Re: Addendum to Preliminary Environmental Noise and Vibration Report
Revised September 18, 2019
Proposed Residential Development
1291 Shore Acres Drive
Town of Innisfil
Our File: 16-120-01

PLAN OF SUBDIVISION
SHOWING MINIMUM
NOISE ABATEMENT
MEASURES

FIGURE 2

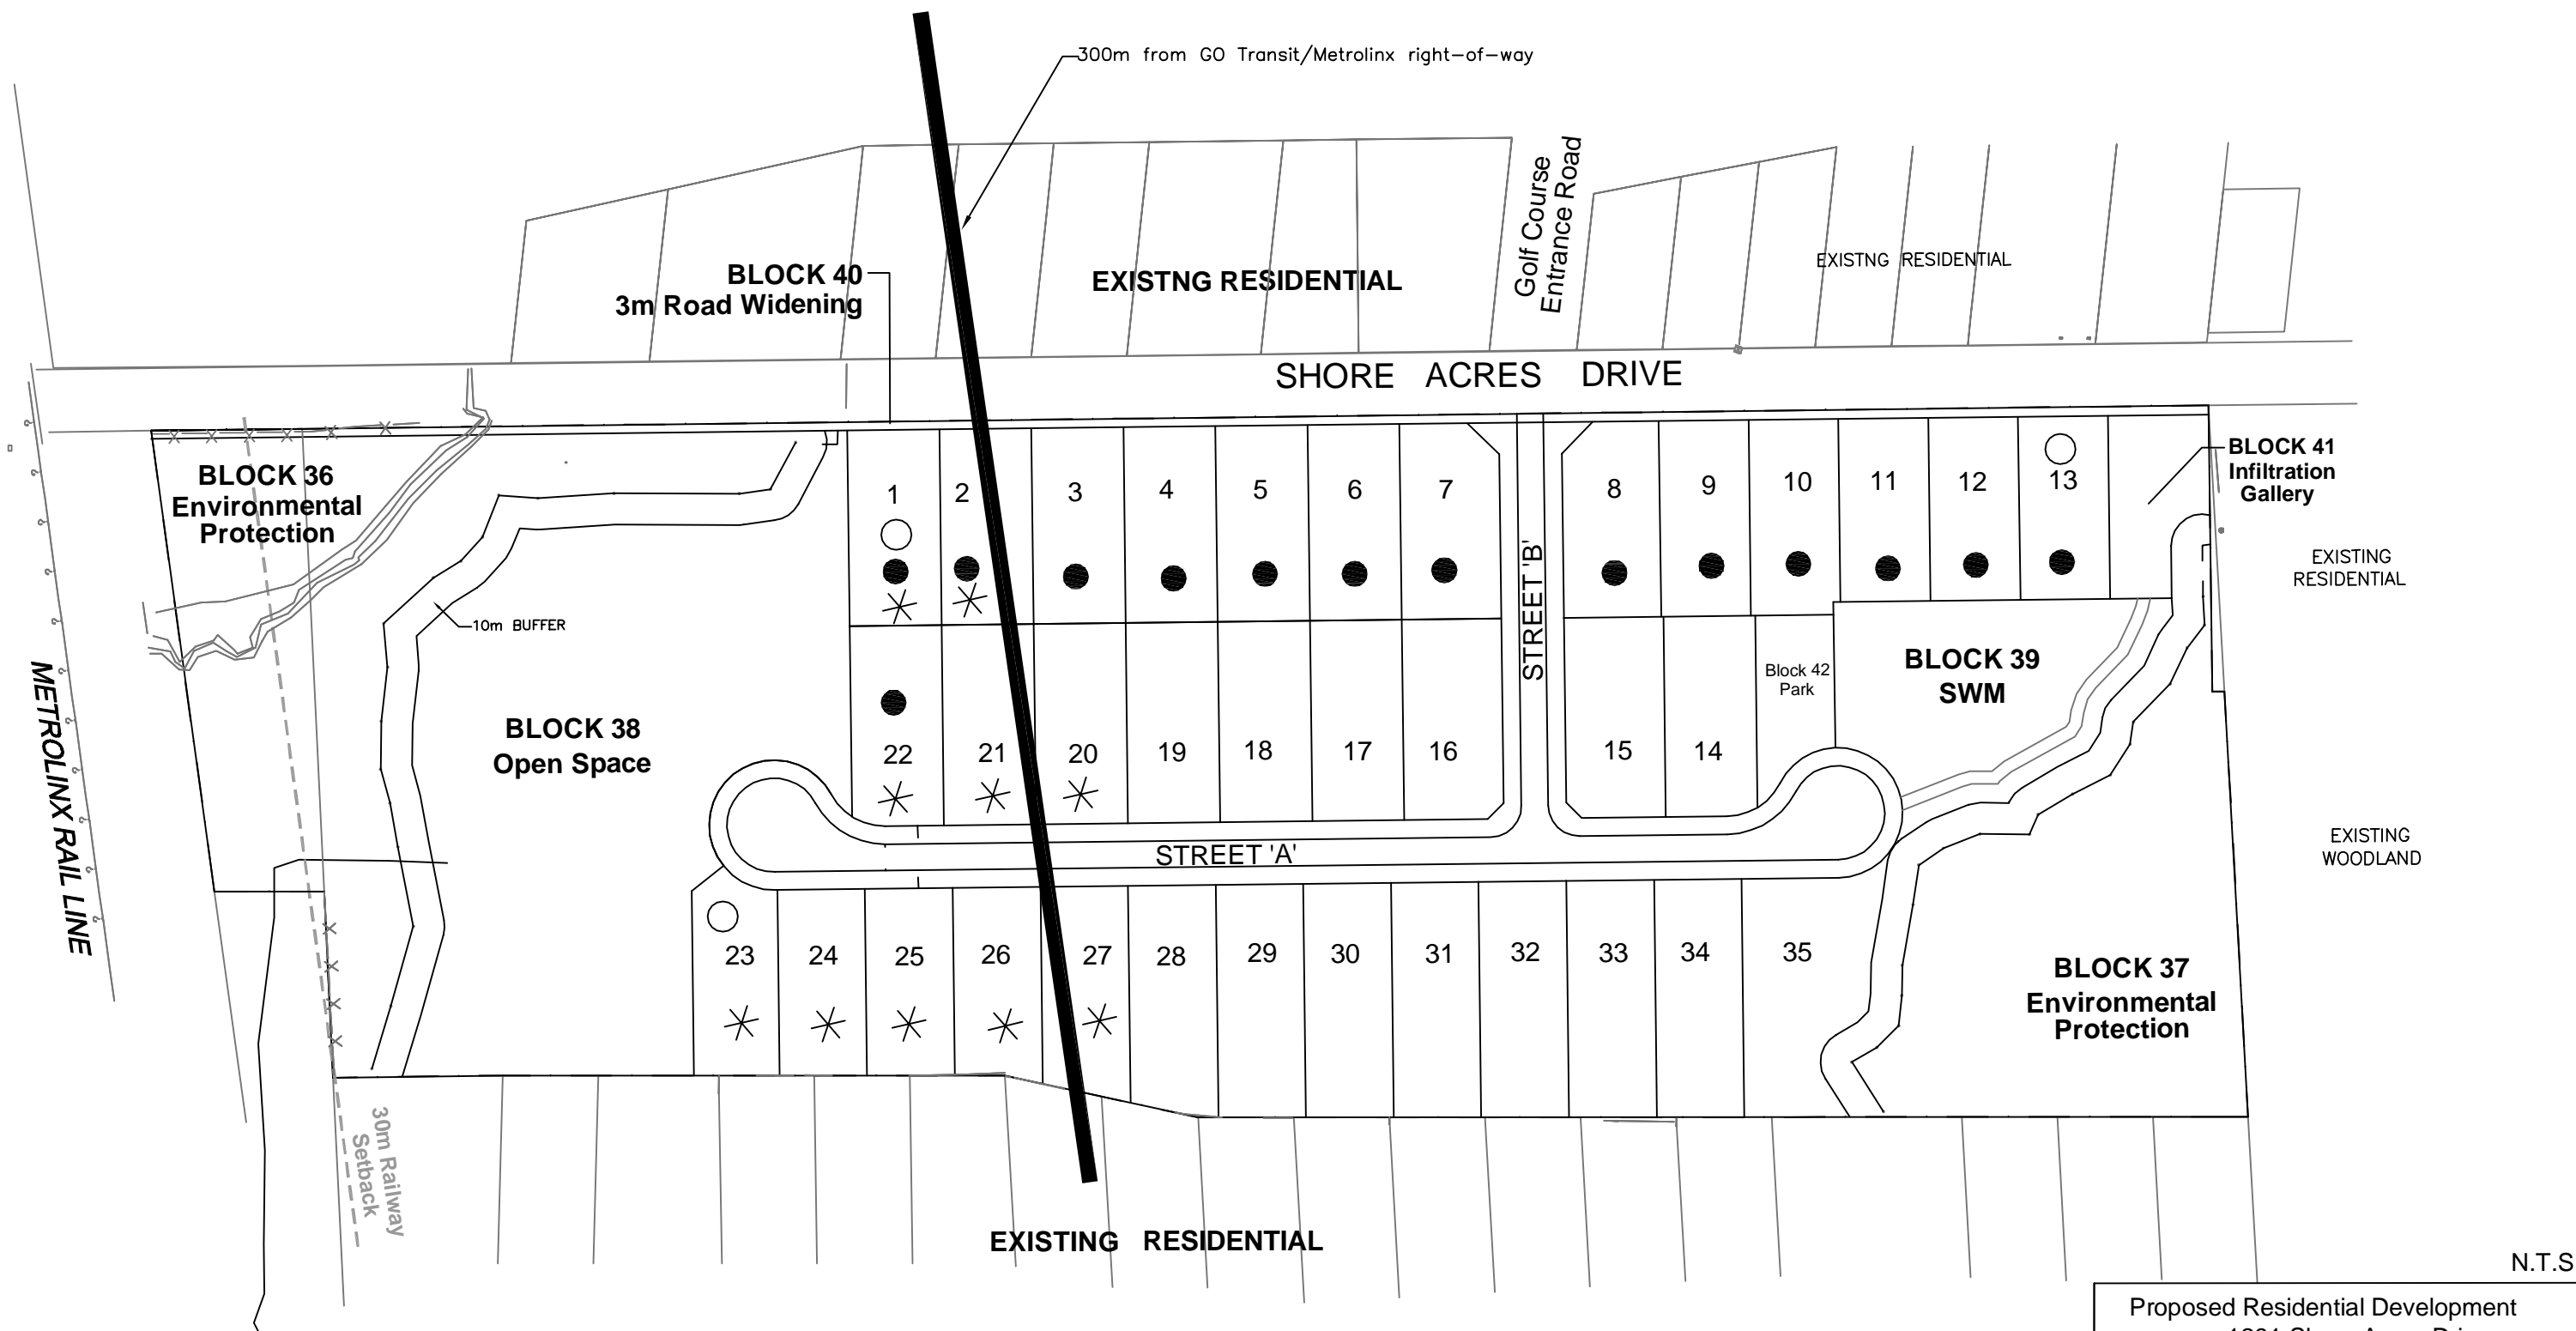
In regard to the original noise report, sample calculations were completed for Lots 1, 12 and 24 (as presented in Table 2). The location and number for Lot 1 is consistent with the original report. For Lot 24, the lot number at this location is now Lot 23. For Lot 12, it was the furthest east lot and was flanking Shore Acres Drive. For this latest Draft Plan, there are no lots flanking Shore Acres Drive and the furthest east lot is now Lot 13. A subsequent change to the analysis has been completed to include Lot 13 in Table 2, which is a representative lot of the lots that front onto Shore Acres Drive.

Attached are Tables 1, 2, 3, Notes to Table 3 and Figure 2 reflecting the latest Draft Plan numbering, road traffic information and site layout as well as showing the acoustic requirements for the residential lots within the respective development.
